ELIMINATION OF LIFT STATION 227 AT WILDERNESS OAKS PART 2
SAWS Job No. 09-2524, Solicitation No. B-10-024-DG

Addendum No. 4

April 30, 2010

LINE A PLAN AND PROFILE

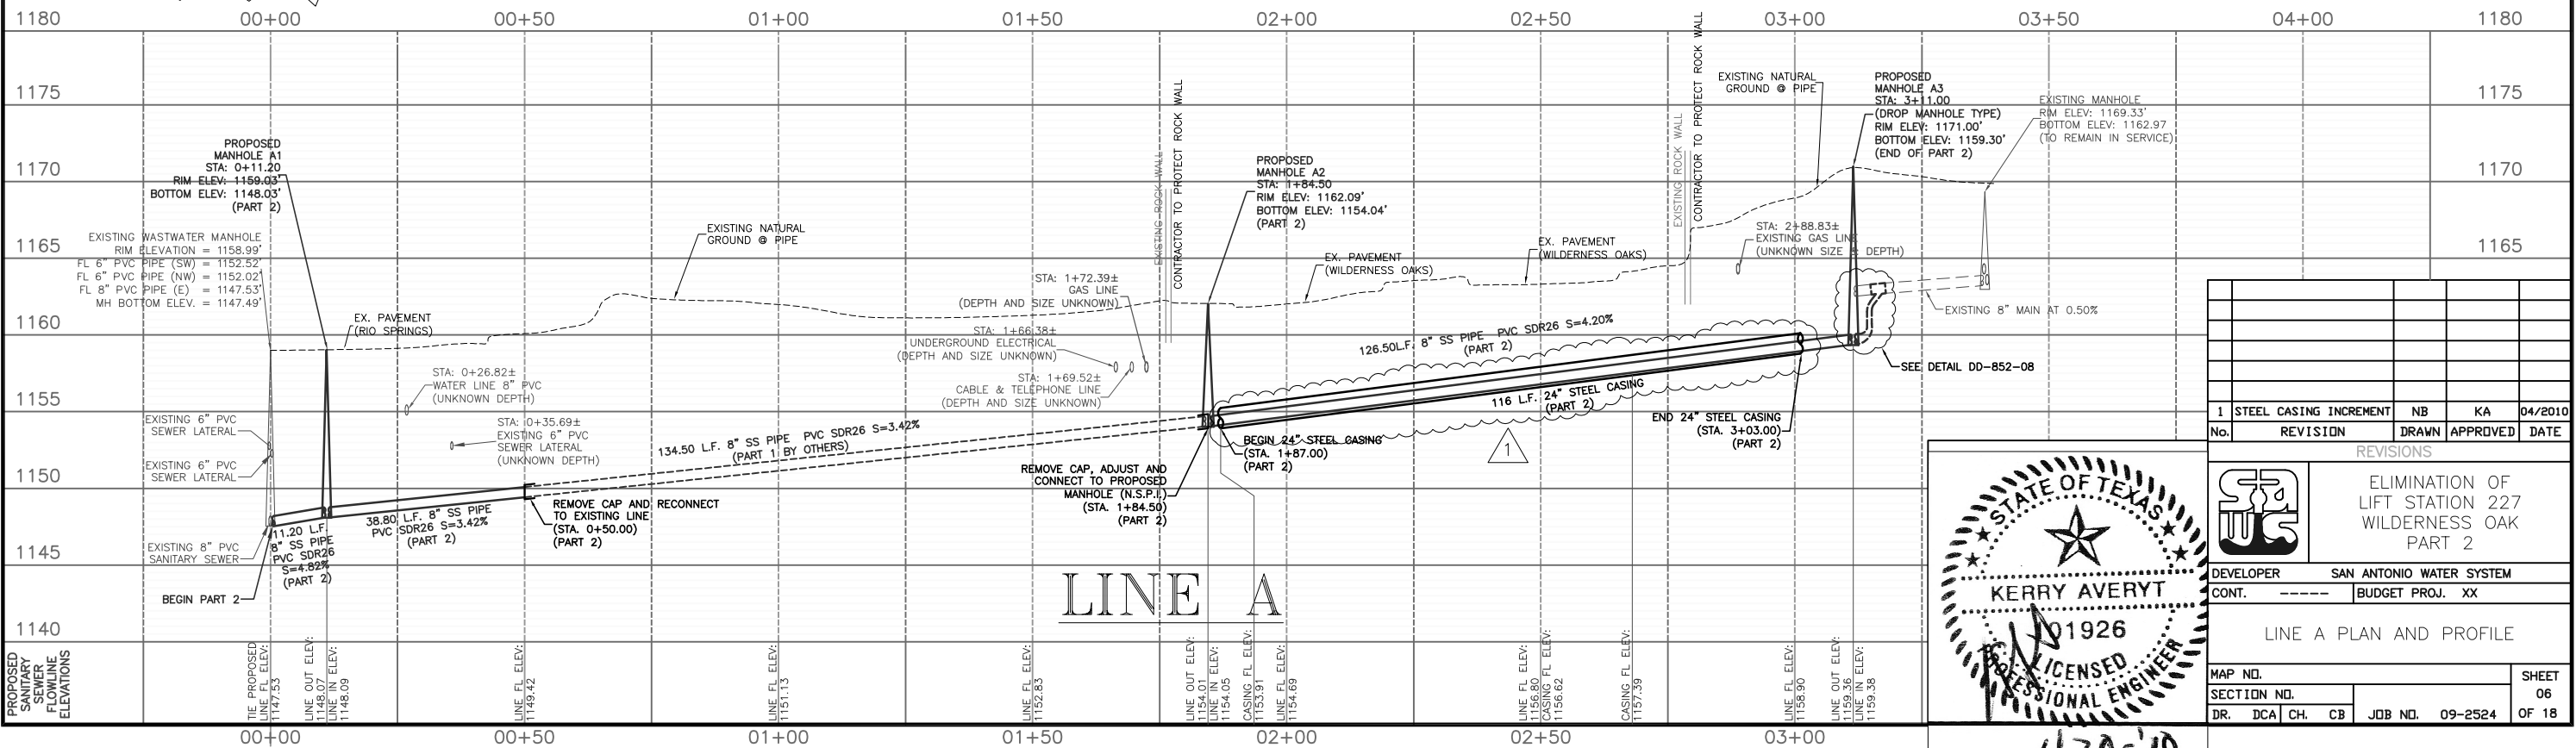
- Item 1 **Modification**
The Bid Opening for this project has changed from Friday, April 30, 2010 at 2:00 p.m. to Monday, May 3, 2010 at 2:00 p.m.
- Item 2 **Bid Proposal**
Please replace previous proposal with attached proposal.
- Item 3 **Plan Sheet**
Remove Sheet 06 of 18 "LINE A PLAN AND PROFILE" in its entirety and replace with attached revised Sheet 06 of 18 "LINE A PLAN AND PROFILE" attached in this addendum.

No.	REVISION	DRAWN	APPROVED	DATE
1	STEEL CASING INCREMENT	NB	KA	04/2010
